Buhl/Rinaldi Subdivision

TOWN OF NEW WINDSOR
PLANNING BOARD
REVIEW COMMENTS

PROJECT NAME: BUHL-RINALDI SUBDIVISION
PROJECT LOCATION: BEATTIE ROAD
NEW WINDSOR #: 86-72
24 FEBRUARY 1988

RURAL STREET SPECIFICATIONS
SCALE: 1/4" = 1'-0"

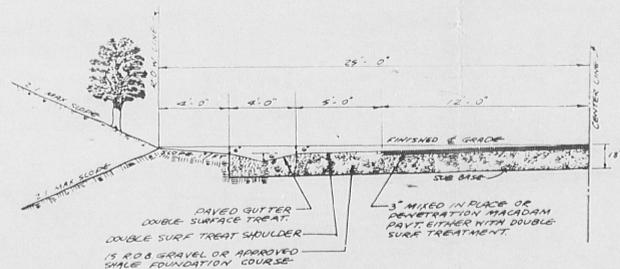
Mr. Grevas: Here is one complete set for the Planning Board Chairman's files. What we have added, the note 4, there should be no subdivision of these lots and there was a question that came up on the typical cross-section today. That cross-section has been changed to conform to the Town's rural road specifications

- 5). On 23 February 1988, the Applicant's Engineering Consultant was advised that the typical roadway cross-section must be corrected to comply with the rural road specifications of the Town Law.

1	CHANGE ROAD CROSS SECTION	2-22-88
ISSUE	REVISION	DATE
